United States Patent and Trademark Office

APPLICATION NO.	FI	ILING DATE	FIRST NAMED INVENTOR	ATTORNEY DOCKET NO.	CONTIRMATION NO.		
10/604,497	(07/25/2003	Andrew Capon	70078-0179	1496		
20915	7590	04/22/2004		EXAMINER			
MCGARR	Y BAIR I	PC		PATEL, M	IITAL B		
171 MONR	OE AVEN	UE, N.W.					
SUITE 600		, - · · · ·	ART UNIT	PAPER NUMBER			
	APIDS M	T 49503	3743				
GRAND RAPIDS, MI 49503				3173

Application No.	Applicant(s)	Applicant(s)		
	10/604,497	CAPON ET AL.		10	
Office Action Summary	Examin r	Art Unit		1/2	
	Mital B. Patel	3743			
The MAILING DATE of this communication app Period for Reply	ears on the cover sheet	with the correspondence a	ıddress\		
A SHORTENED STATUTORY PERIOD FOR REPLY THE MAILING DATE OF THIS COMMUNICATION. - Extensions of time may be available under the provisions of 37 CFR 1.13 after SIX (6) MONTHS from the mailing date of this communication. - If the period for reply specified above is less than thirty (30) days, a reply - If NO period for reply is specified above, the maximum statutory period was period for reply within the set or extended period for reply will, by statute, any reply received by the Office later than three months after the mailing	36(a)

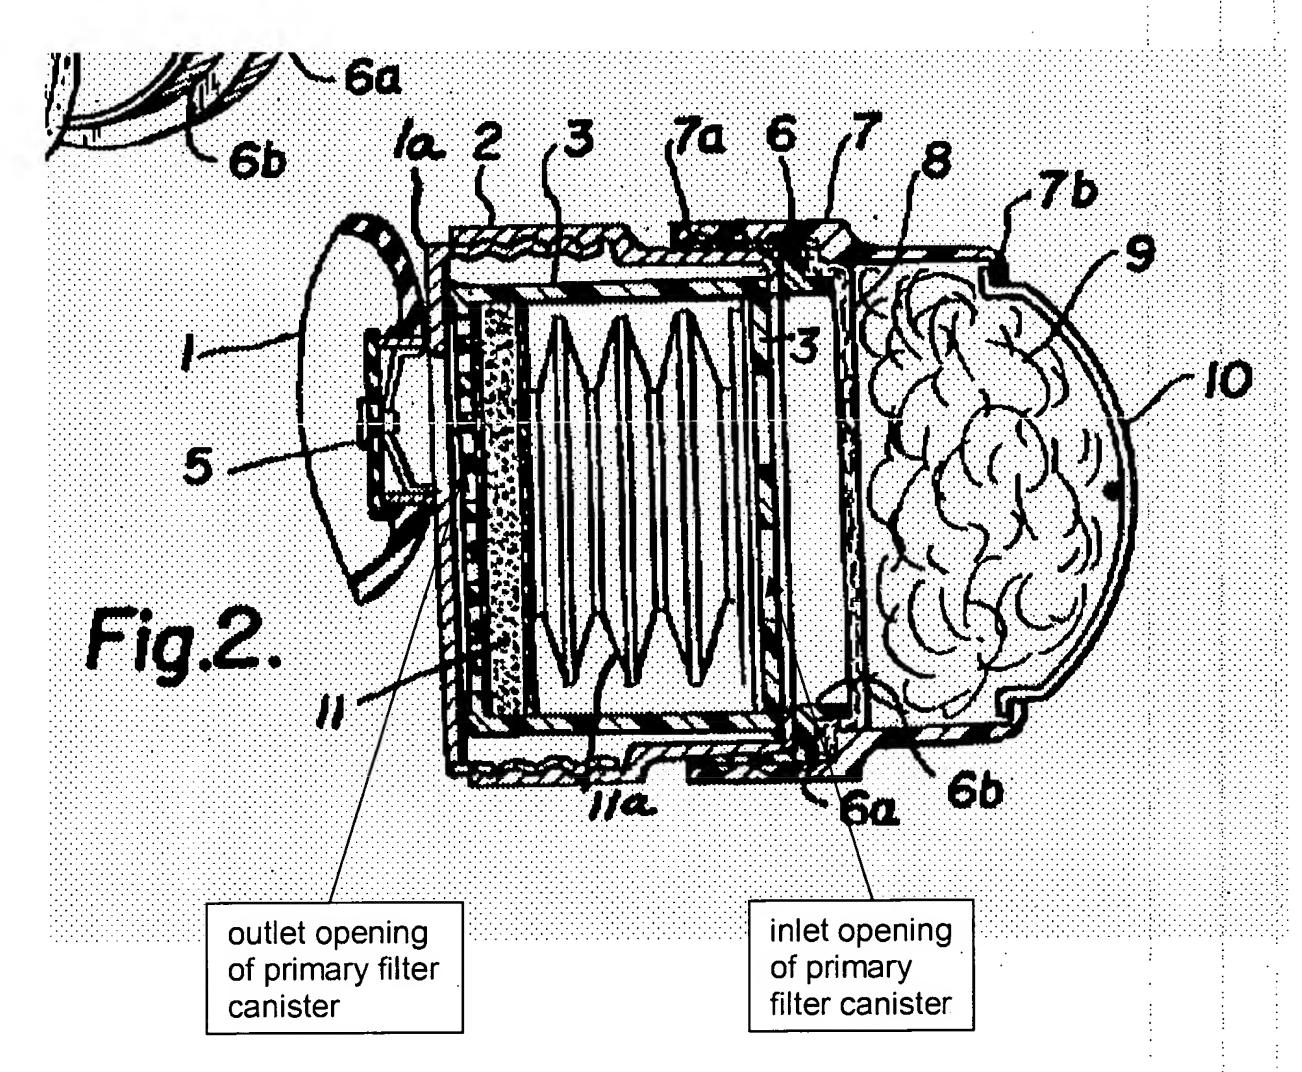
- 5. Claims 1 and 7, 9, and 11 are rejected under 35 U.S.C. 102(b) as being anticipated by Klusewitz et al (US 3,142,549).
- 6. As to claim 1, Klusewitz et al teach a filter canister assembly (See Fig. 2) for a gas mask 1 comprising: a primary filter canister 2,3 with an inlet opening at a first end (See Fig. 2 attachment below) and an outlet at a second end (See Fig. 2 attachment below); a first filter medium 11a adapted to remove aerosols, particulate materials and droplets from air and mounted in the primary filter canister in communication with the primary filter canister inlet opening; a second filter medium 11 adapted to remove toxic gases and arranged in serial communication with the first filter medium in the primary filter canister and with the outlet opening in the first filter housing, whereby the first filter and second filter media are capable of filtering out contaminants in normal hostile environments; and a supplementary filter canister 7 having an inlet opening (that formed at 7b) at a first end 7b and an outlet opening (that formed at 7a) at a second end 7a, the supplementary filter canister second end is removably (See Figs. 1-2) mounted to the primary filter canister first end so that the primary filter canister inlet opening is in communication with the supplementary tilter canister outlet opening; and a third filter media 8,9 adapted to filter toxic industrial materials and mounted in said supplementary filter canister in communication with the inlet and outlet openings in the second filter canister.
